Technical Service Bulletin

LIFTGATE SWITCH DOES NOT WORK

Bulletin No.: 09-004/22

Last Issued : 01/27/2022

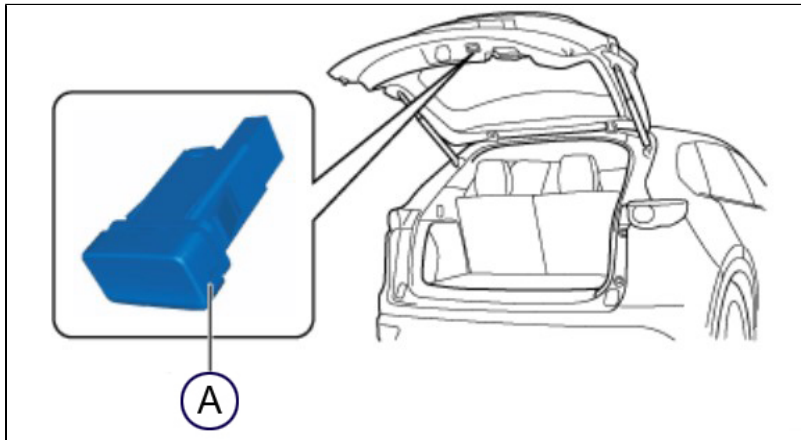
Some CX-5 and CX-30 customers may find that the liftgate does not close when pressing the power liftgate (PLG) rear switch (A) located on the interior liftgate trim. This may be caused by PLG switch corrosion. Water from a high pressure car washer and/or condensation may drip onto the switch connector and cause corrosion.

To eliminate this concern, the PLG rear switch has been modified with a waterproof connector.

Before Wrapping	After Wrapping

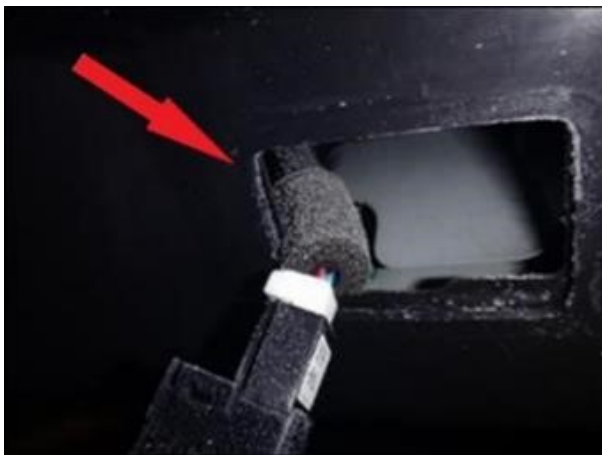
- While wrapping either upwards or downwards, use the half-overlapping method.
- To seal any possible gaps from water entry, stretch the tape a little to make it fit securely to the shape of the switch and coupler.
- In the image below, the thick foam rubber is not illustrated (the connector used for this photo did not have this part), but it is important as a position reference during the wrapping.
